**NATS South Coast Airspace Change Proposal
Consultation Feedback Report Part B**

NATS South Coast Airspace Change Proposal - Consultation Feedback Report Part B

Figure 5 Proposed airspace volumes along the south coast – modified following consultation feedback

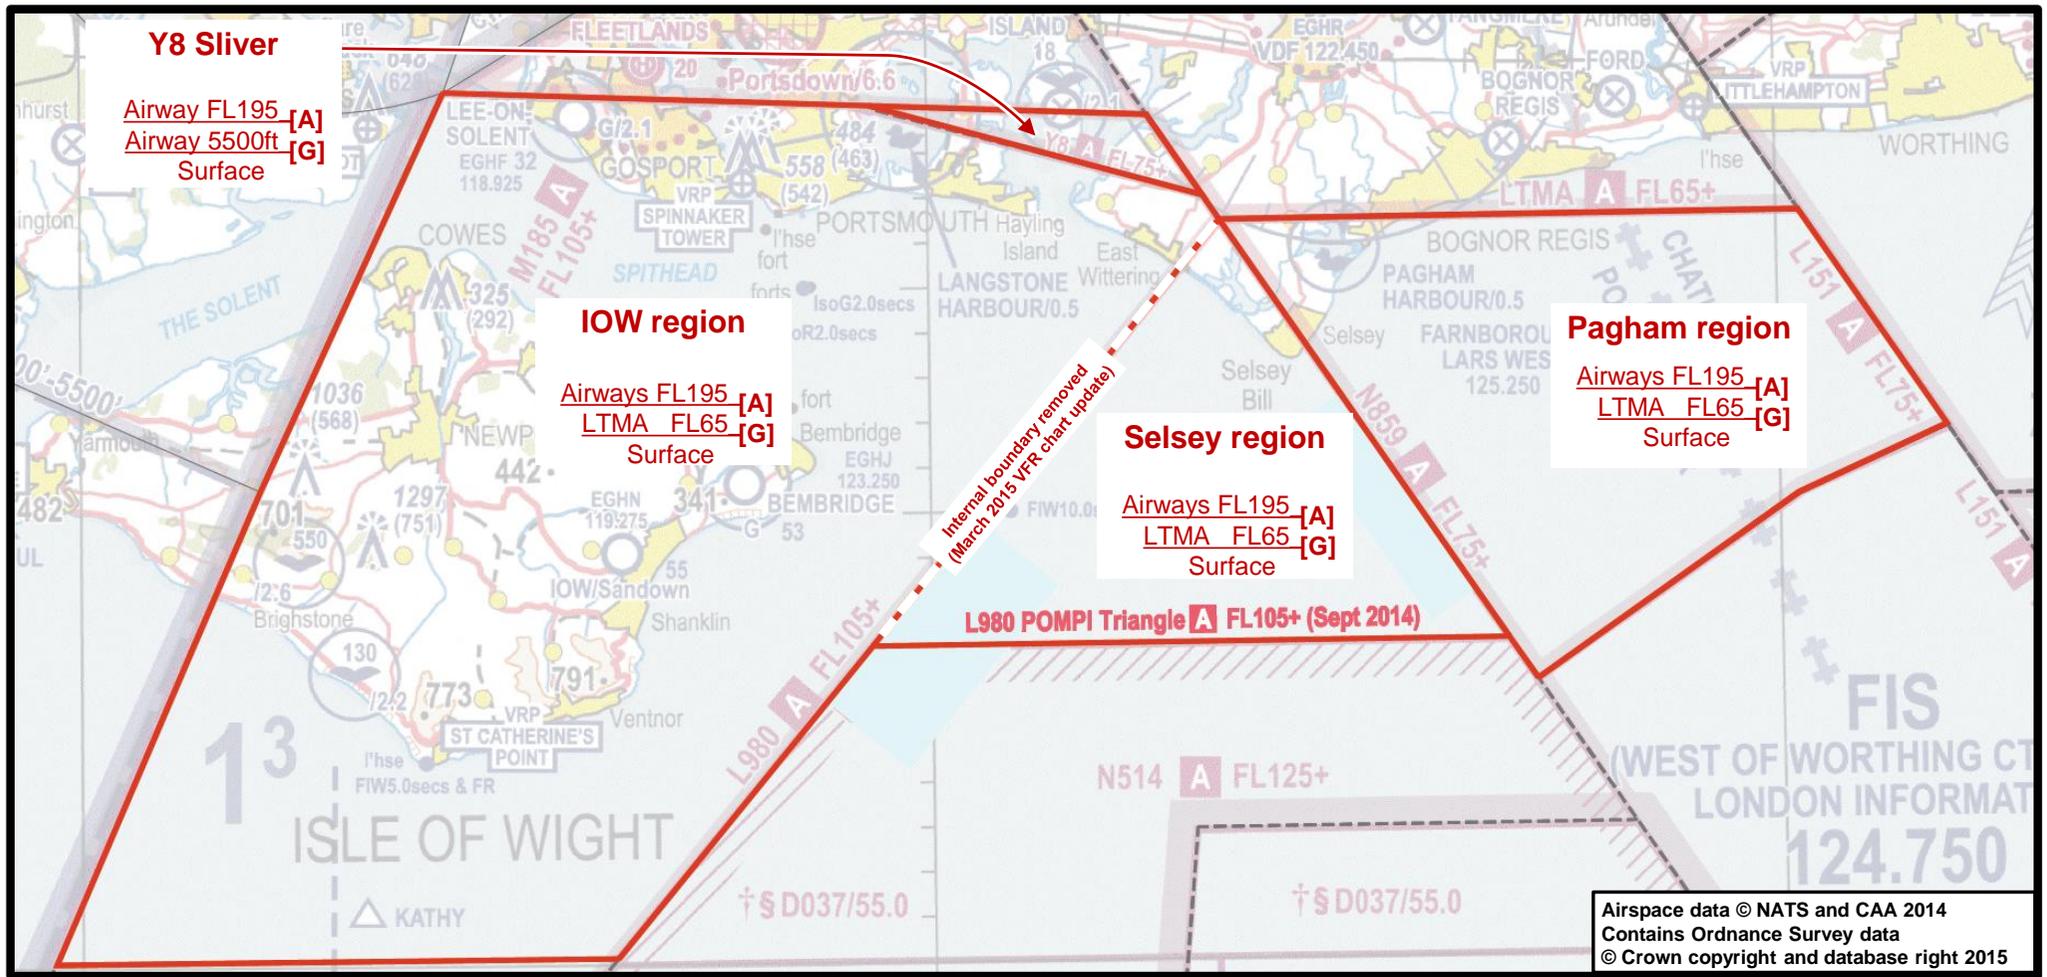
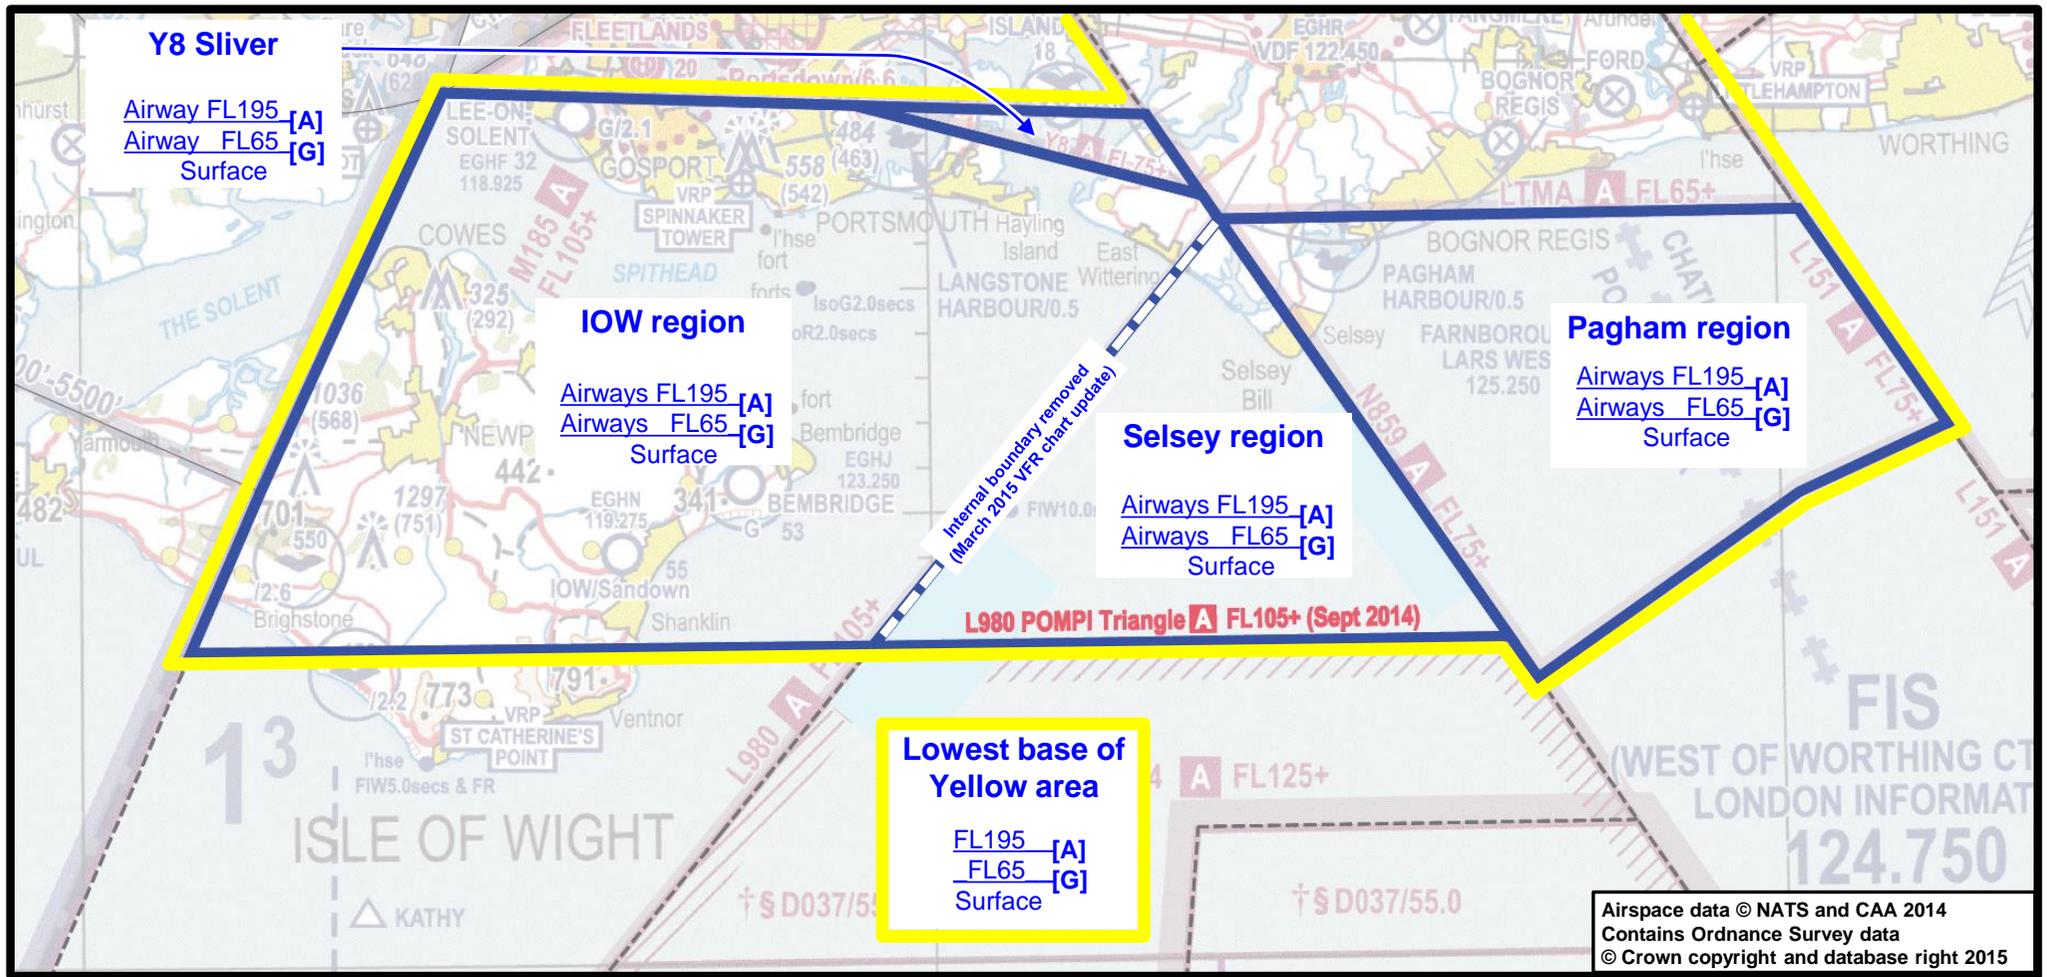
- 4.4 The majority of aviation comments concerned adverse impacts on non-airways airspace users due to proposed lowering of the base of Class A airways.

- 4.5 These expectations are borne out by the results illustrated in Figures 53, 54, 56, 65, and 72-74 of TAG Farnborough's Consultation Feedback Report Part A (Ref 4). Concerns about impact on other airspace users, safety, airspace dimensions and design were all raised.

- 4.16 Some stakeholders were concerned that the VFR recommended route to France and the Channel Islands would be impacted by the proposal. This route is marked on VFR charts as a southbound blue dashed line starting west of St Catherine's Point lighthouse VRP. Higher-altitude spin/stall training and aerobatics were also mentioned by some stakeholders as being impacted. The proposed shrinking of the IOW region would mitigate the concerns of the users of that VFR route, and would partly mitigate concerns of compression with respect to aerobatics and spin/stall flight training.

- 4.17 Funnelling/compression of GA aircraft beneath the Class A areas was a concern raised during consultation.
- 4.18 TAG Farnborough's Consultation Document Part E (Ref 3) Section 15 stated that, based on expert operational view, the majority of GA VFR activity occurs below FL65 in these regions.

- 4.9 Figure 4 and Figure 5 respectively show the CAS originally proposed for the South Coast region by the TAG Farnborough consultation, and the revised CAS now being proposed by NATS considering the consultation feedback. All CAS to the north would be unaffected by the South Coast proposal.
- 4.10 The alignment of the arrival routes within the CAS will remain as per the consultation as far as the Goodwood (GWC) VOR. Low level route changes and CAS to the north are not proposed here; these would also be the responsibility of TAG Farnborough to progress at a later date).

- 4.11 We have identified that, rather than make the CAS base of this airway sliver 5,500ft to match the LTMA to the northwest, as originally planned, it could be made FL65 to match the consulted-upon CAS to the south.
- 4.12 In line with consultation feedback and comments this would make the region's FL65 base more uniform and easier to navigate & to chart.

- 4.13 We modified the proposal so that arrivals from the southwest do not descend as early as originally envisaged.
- 4.14 The Southampton and Bournemouth radar-vector arrival flows from the east would follow the paths described in TAG Farnborough's Consultation Document Part D Figures D8 and D9 (Ref 3), but we have developed procedures so they would not proceed further south than illustrated. This allows us to truncate the IOW region to the same southern edge as the Selsey triangular region.

- 4.15 The revised CAS boundary between FL105 and FL65 is now proposed to run roughly east-west between southern Shanklin and Brighstone. This would leave an area of approximately 100nm² in the southern IOW region with a base of FL105 as it is today.
